DA2024/1427

REVISION	DESCRIPTION	DATE
A	DEVELOPMENT APPLICATION ISSUE - NOT FOR CONSTRUCTION	14.10.2024
B	RFI 1	29.01.2025

ADDRESS
14 BAREENA DRIVE, BALGOWLAH HEIGHTS, NSW 2093

1 PROPOSED GROUND FLOOR PLAN
1 : 100

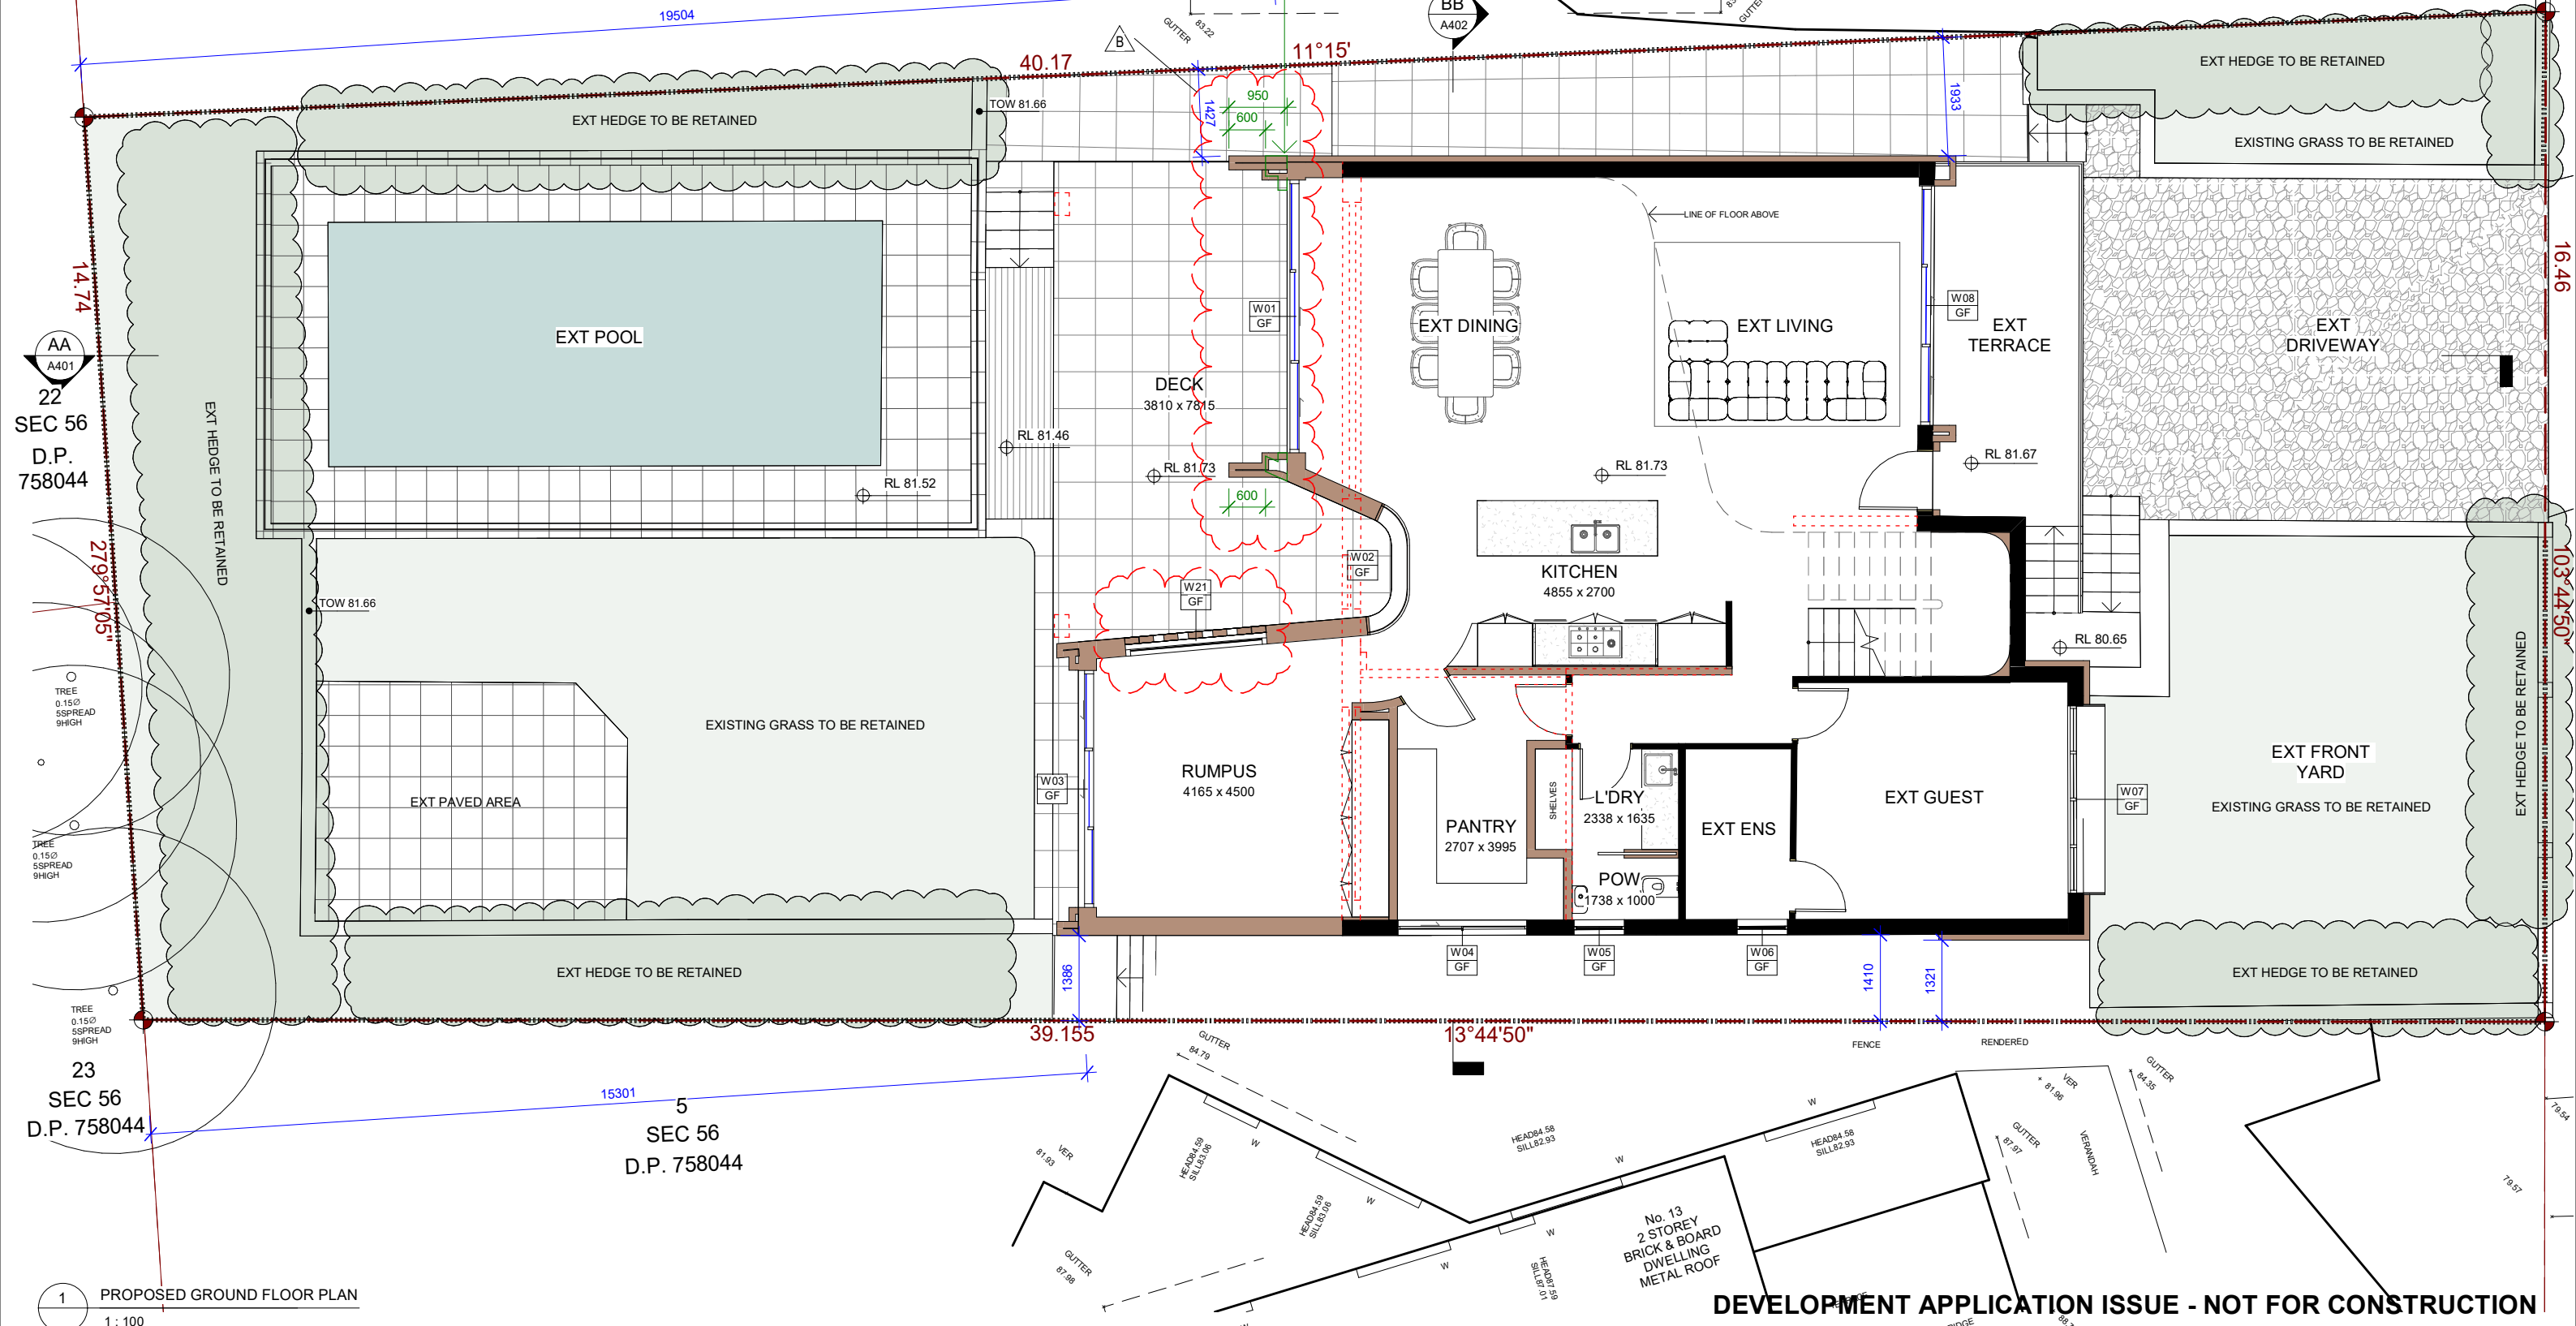
ORIGINAL DA2024/1427 WALLS LOCATION SHOWN IN GREEN DASHED
LINES.
THE EXTERNAL FEATURE WALLS ARE FURTHER EXTENDED OUT BY
ANOTHER 600MM TO MINIMISE OVERLOOKING TO THE WESTERN
NEIGHBOUR.

ADDRESS		DRAWING TITLE	
14 BAREENA DRIVE, BALGOWLAH HEIGHTS, NSW 2093		ROOF PLAN	
DRAWN BY.	SCALE @ A3	PROJECT NO.	REV
ZH	1 : 100	24.02	B
		DRAWING NO.	
		A306

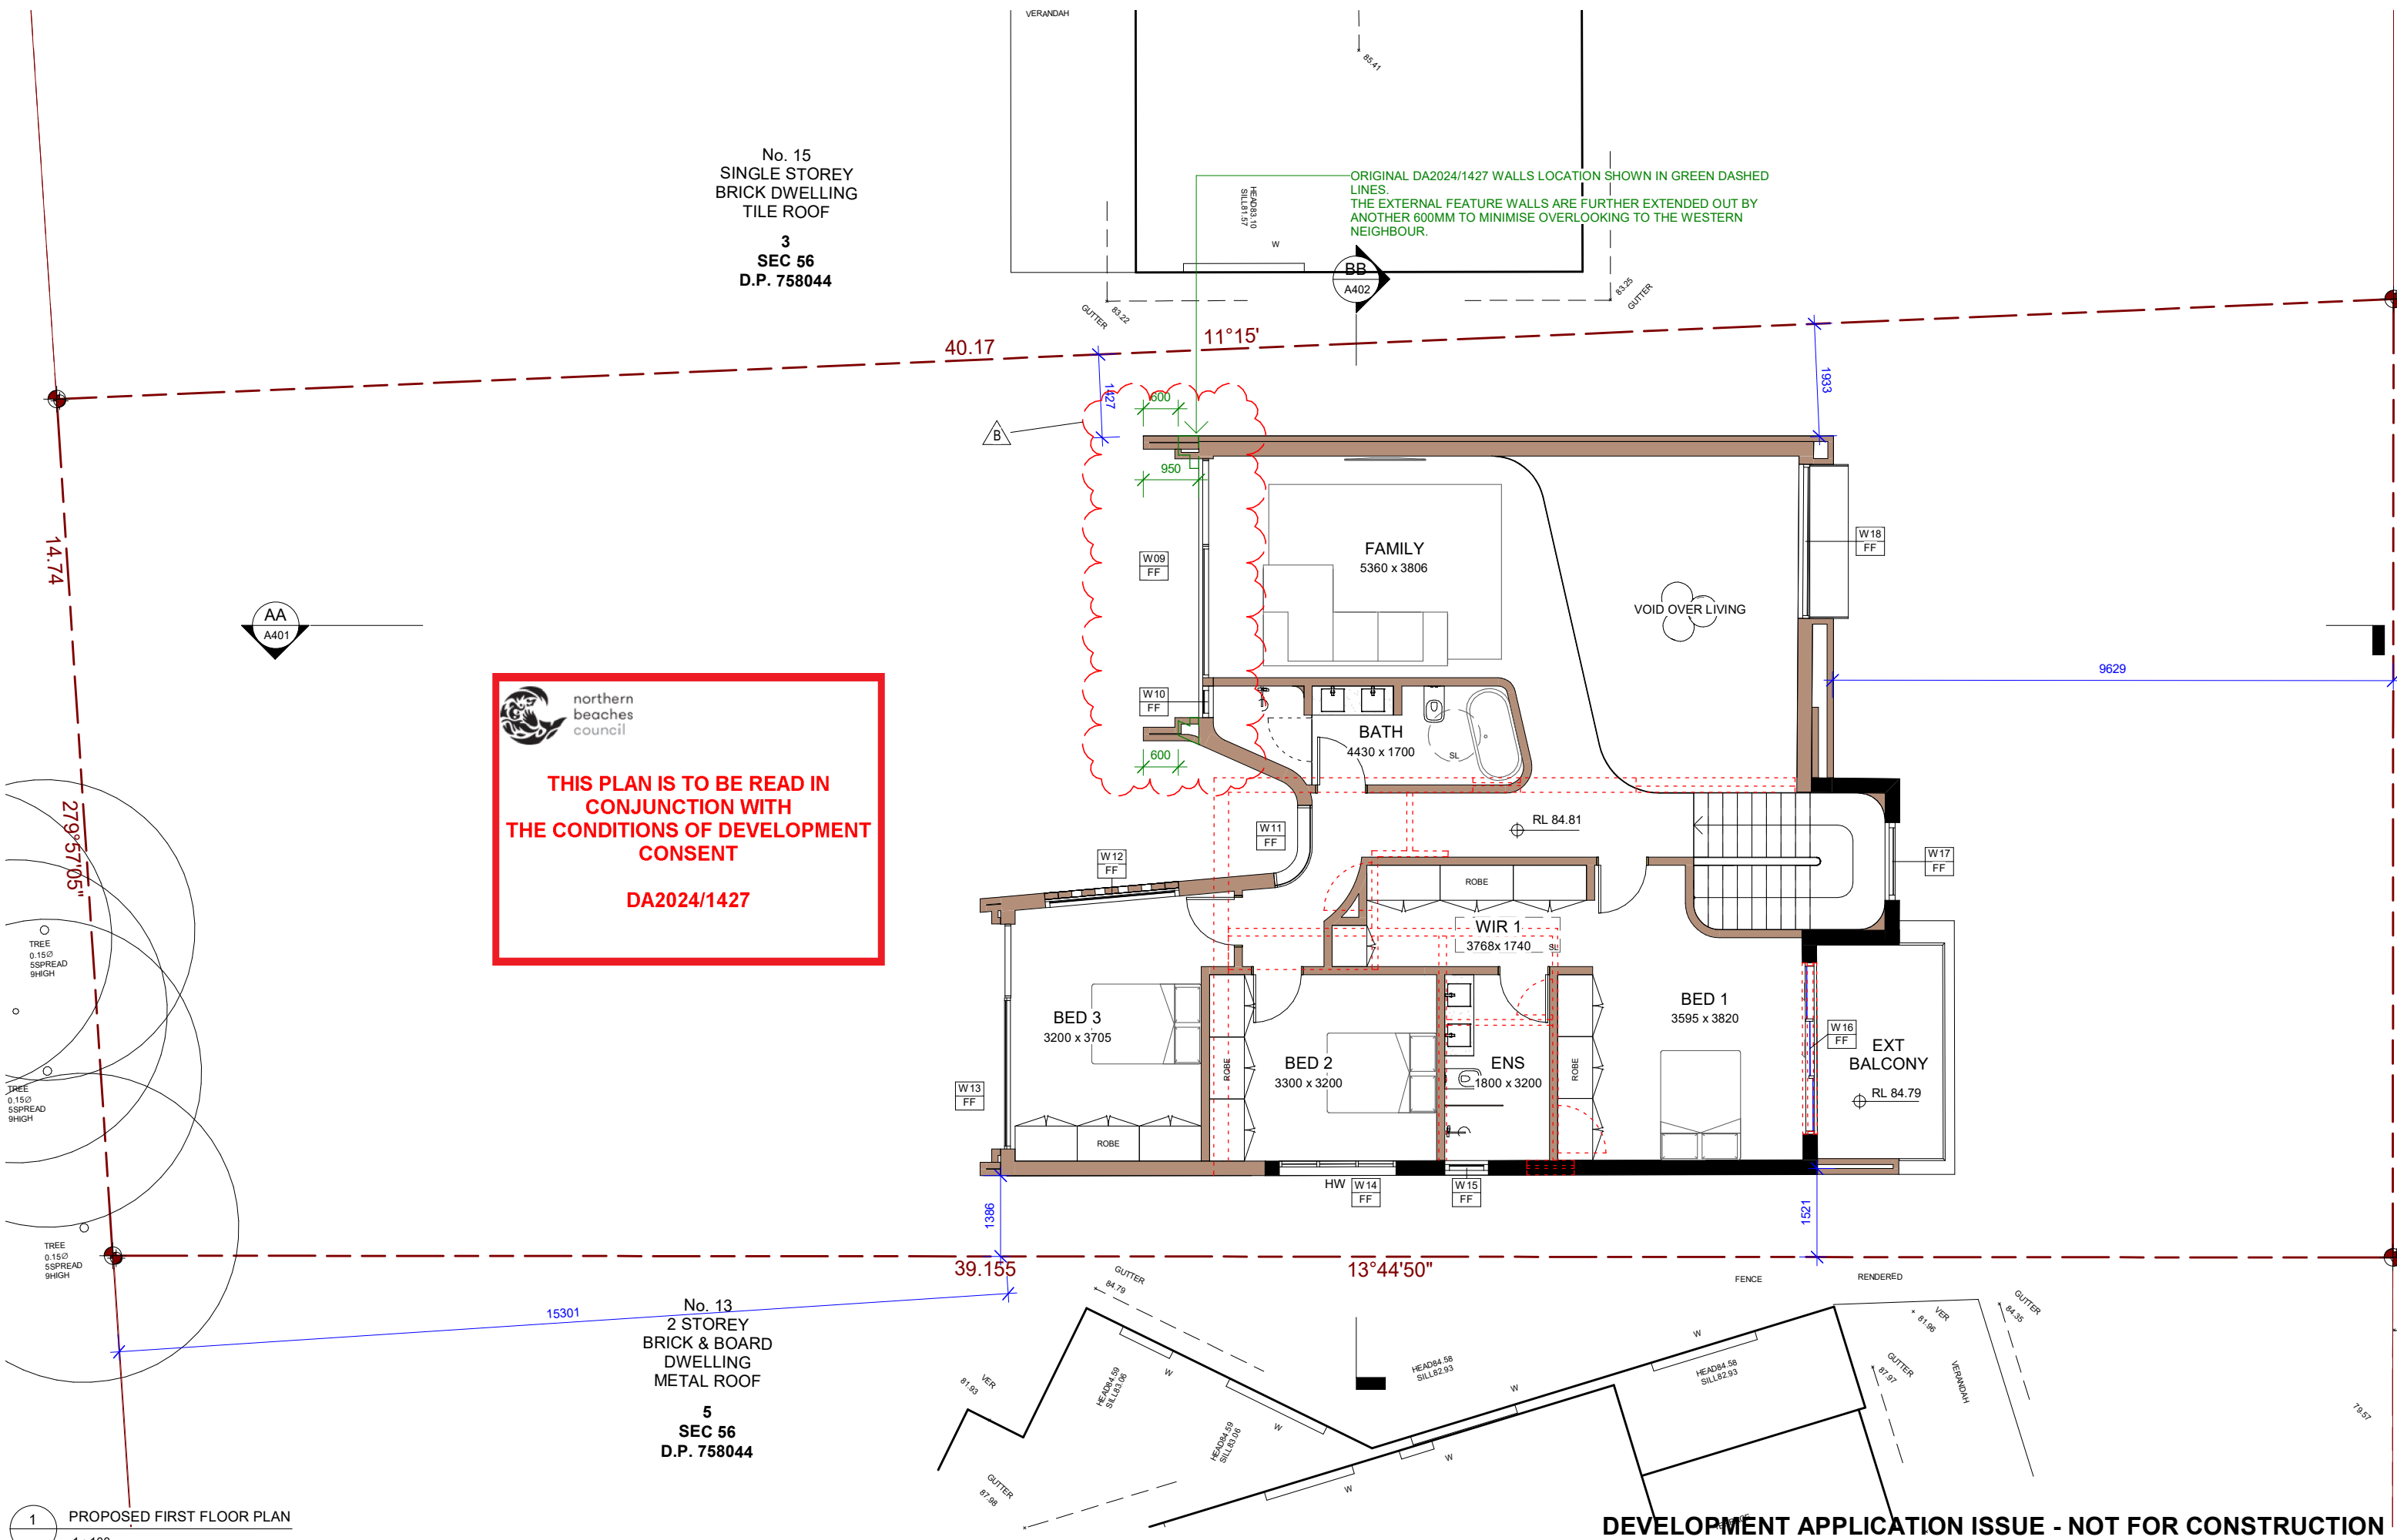
ORIGINAL DA2024/1427 WALLS LOCATION SHOWN IN GREEN DASHED LINES.
THE EXTERNAL FEATURE WALLS ARE FURTHER EXTENDED OUT BY ANOTHER 600MM TO MINIMISE OVERLOOKING TO THE WESTERN NEIGHBOUR.

LANDSCAPE PLAN

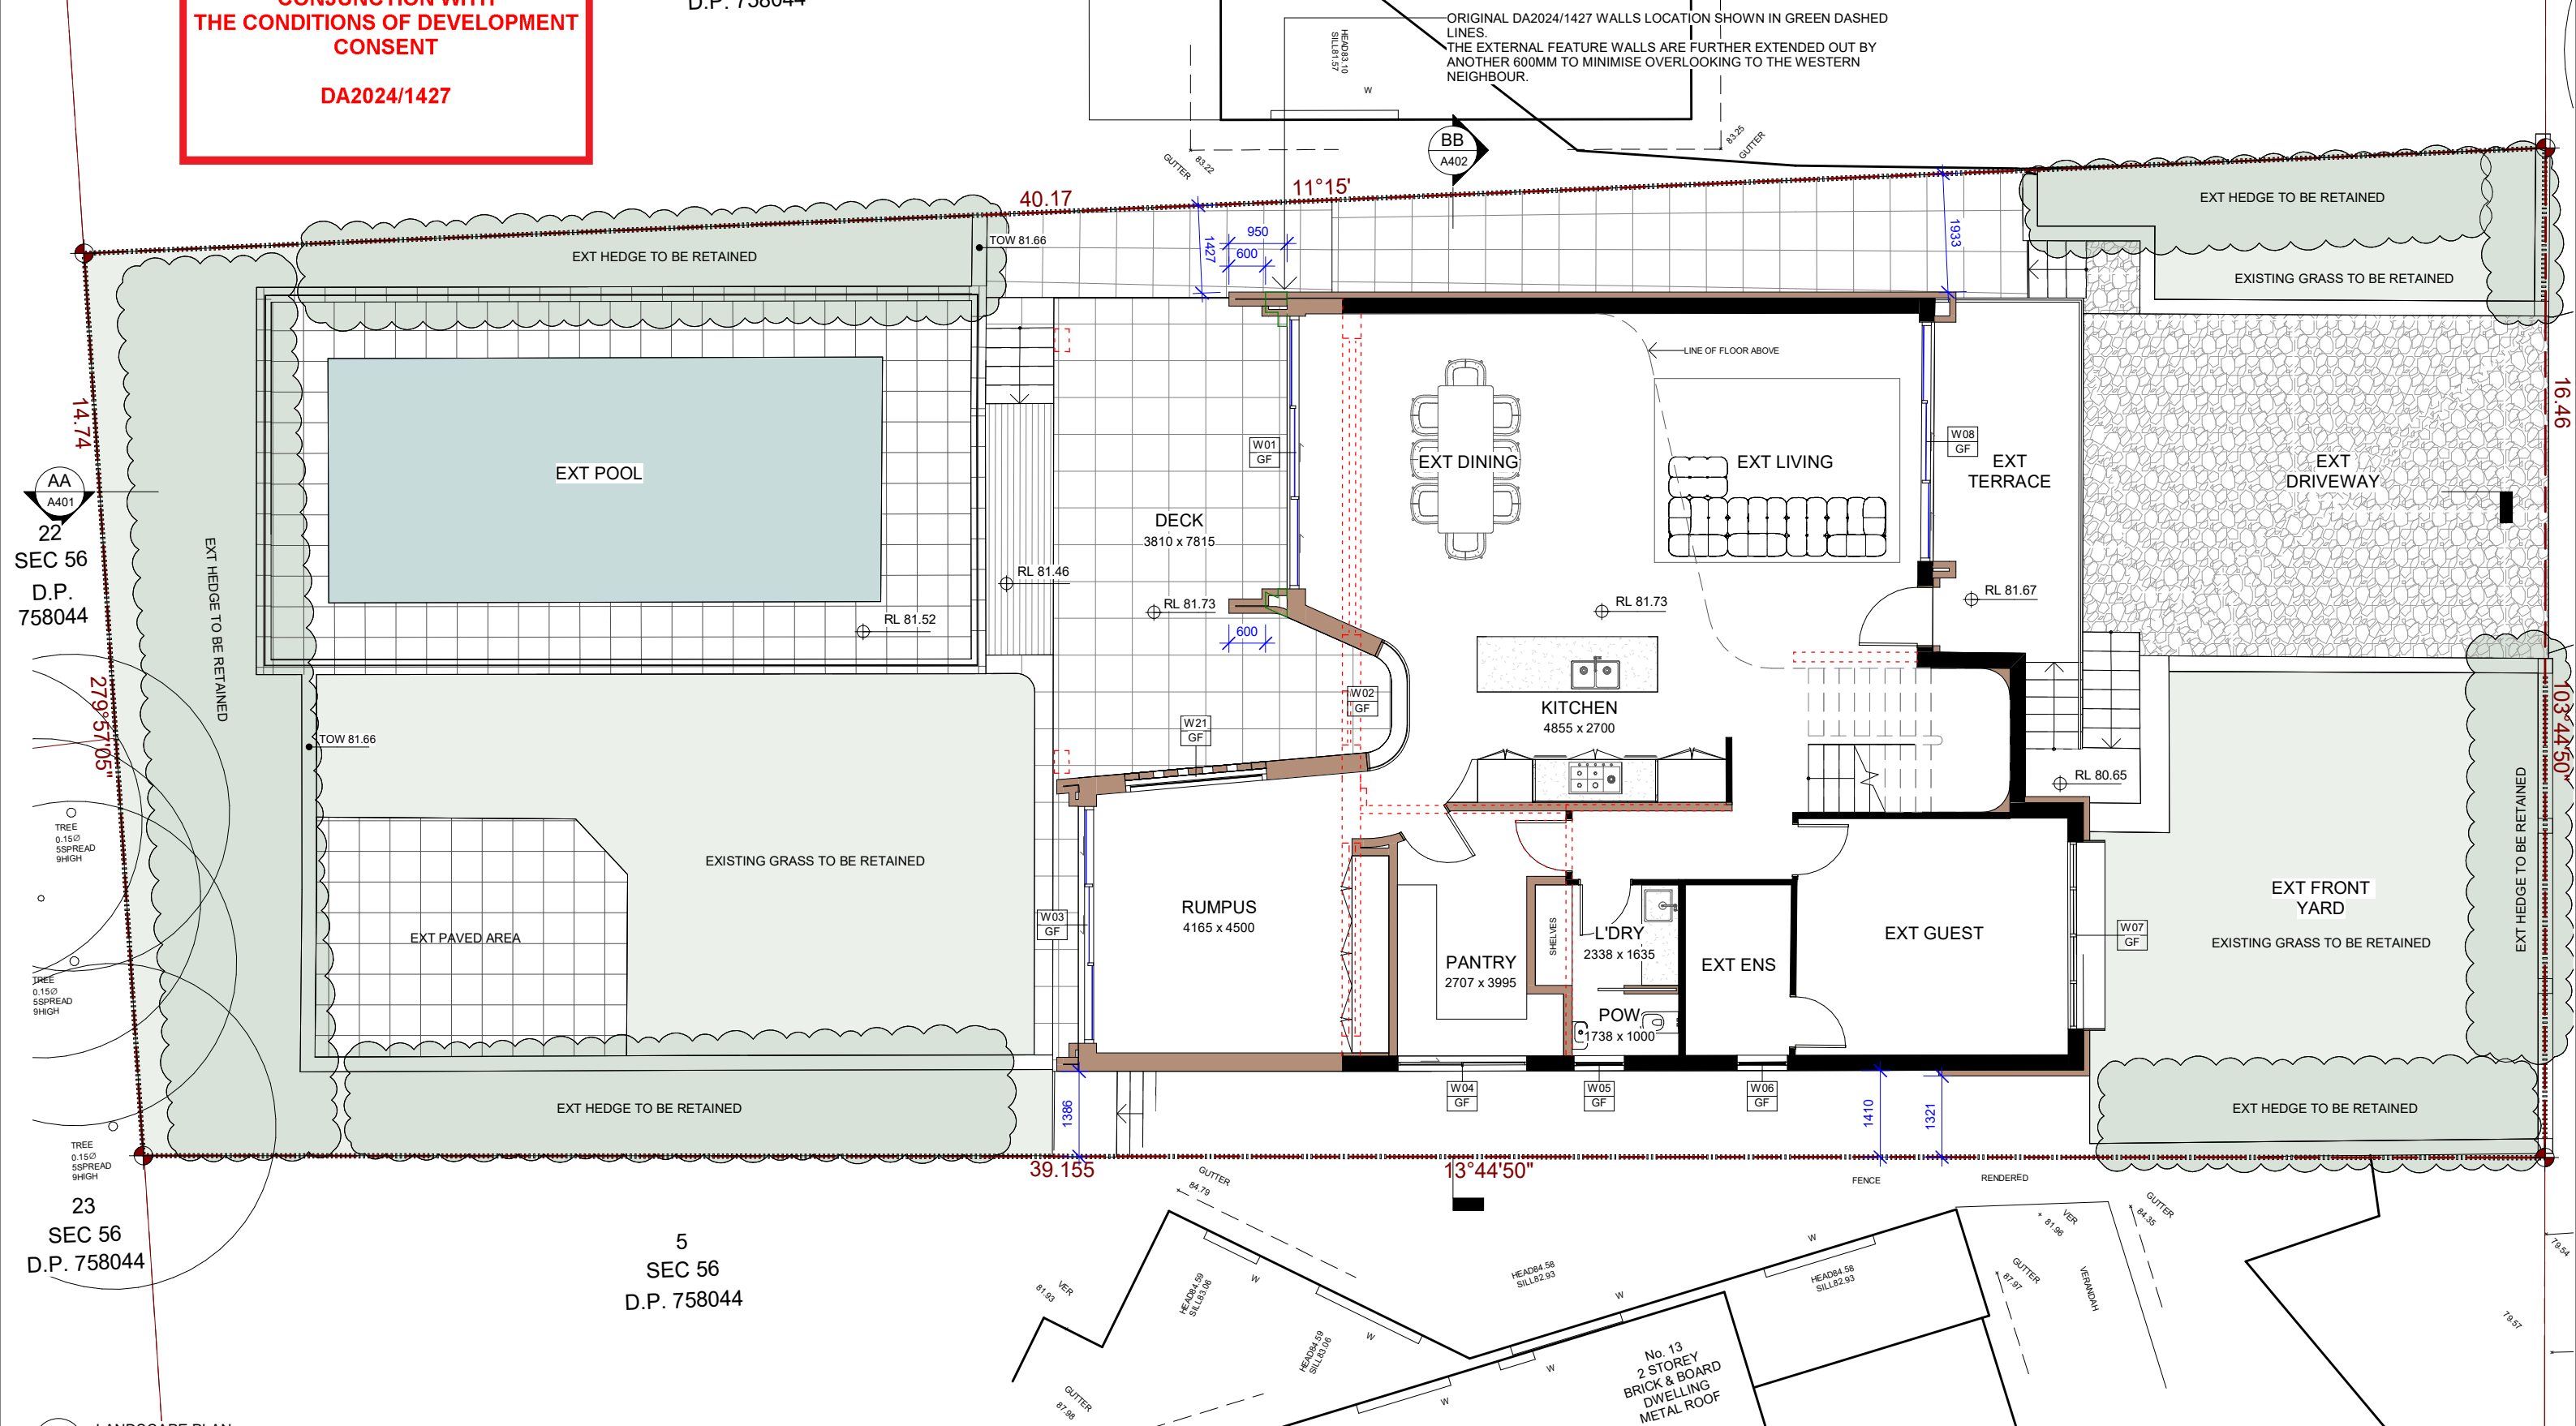
— ORIGINAL DA2024/1427 WALLS LOCATION SHOWN IN GREEN DASHED LINES.
— THE EXTERNAL FEATURE WALLS ARE FURTHER EXTENDED OUT BY ANOTHER 600MM TO MINIMISE OVERLOOKING TO THE WESTERN NEIGHBOUR.
